APPLICATION FOR MODIFICATION ASSESSMENT REPORT

Application Number:	Mod2020/0101
Responsible Officer:	Renee Ezzy
Land to be developed (Address):	Lot CP SP 10040, 46 Victoria Parade MANLY NSW 2095
Proposed Development:	Modification of Development Consent DA367/2010 granted for demolition of existing and construction of a seven 7 storey Residential Flat Building containing eleven 11 units with two 2 levels of basement car park decks and landscaping
Zoning:	Manly LEP2013 - Land zoned R3 Medium Density Residential
Development Permissible:	Yes
Existing Use Rights:	No
Consent Authority:	Northern Beaches Council
Delegation Level:	NBLPP
Land and Environment Court Action:	No
Owner:	Proprietors of Strata Plan 10040
Applicant:	Mod Urban Pty Ltd

Figure 1 - The proposed balcony extension and reconfigured planter box at Level 3.

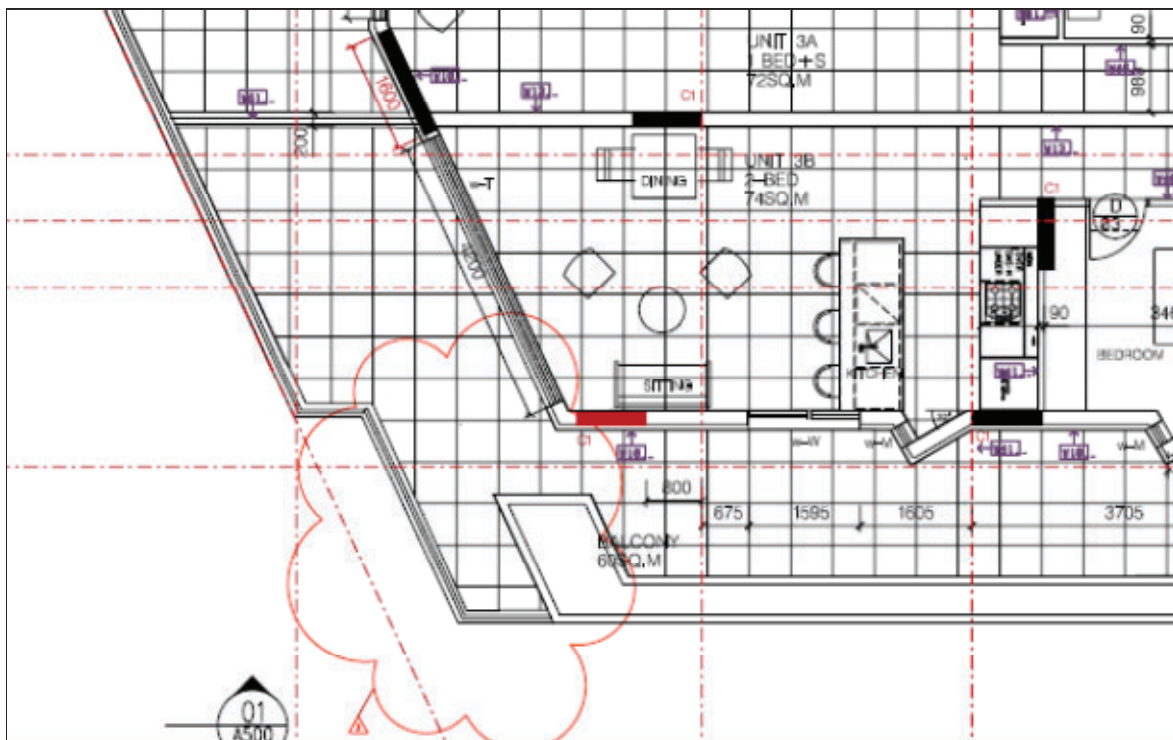
The modification seeks to demolish part of the existing planter and extension to the glass balustrade at the north-western corner of Level 3 of the building.

Figure 3 - Planter box as proposed (MOD2020/0101)

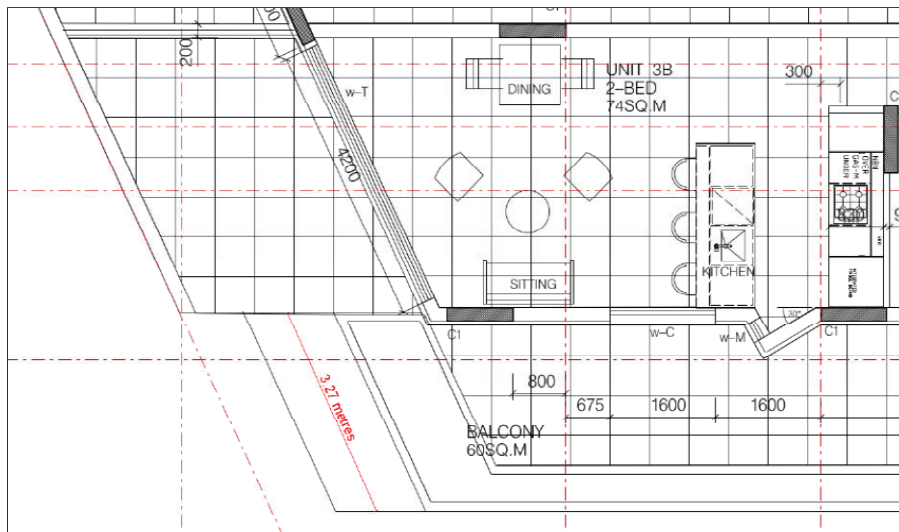
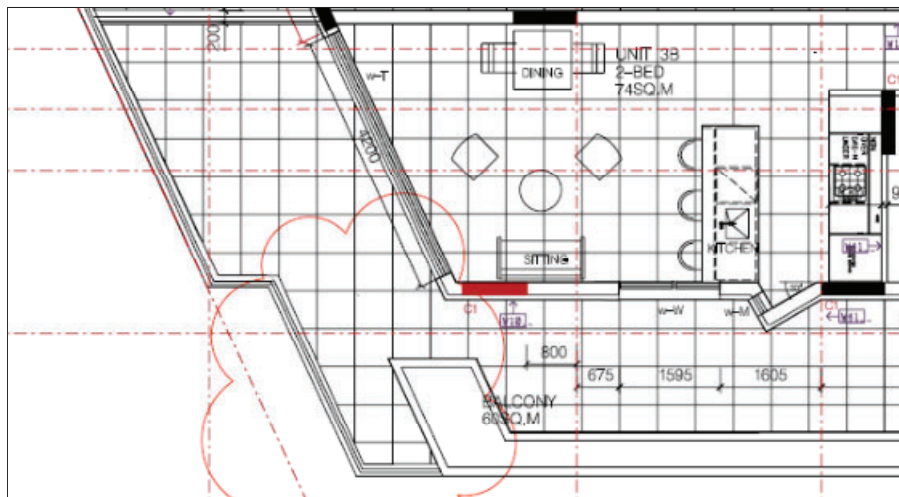
The area which is the subject of this modification is a ledge section which forms part of the roof for the apartment below and represents an architectural relief to the facade and stepping of the building form as the building increases in height.

As can be seen from the photo from the subject site and the neighbouring property, this ledge will provide negligible usable space for the occupant of the unit due to its shape and size, however it will enable people to stand in that location and be 3m closer to occupants of the adjoining building and their primary living area. The planter box behind this ledge has not been constructed in accordance with the approved plans which had this element extending across the terrace in line with the ledge effectively restricting access to the western side balcony area. While the reduced planter can be supported to enable direct access to this secondary outdoor area, the inclusion of the ledge as part of the terrace is not supported.

The owner of the subject apartment has stated that keeping the ledge clean and free of dirt and bird droppings was the main reason to extend the deck to include this area. The building contains numerous similar details forming the facade of the building and cleaning this area is not considered to be a sufficient justification for the change considering the additional impact on the adjoining properties.

Further, the facade of the building at each level incorporates either a planter box or physical recession to ensure the overall bulk and scale of the development is reduced as the building increases in height.

No consent is given or implied for any extension of the north facing balcony at Level 3 adjoining Unit 3B (known as Unit 8) to include the existing rendered ledge. This north facing balcony should be retained as approved by MOD2019/0029.
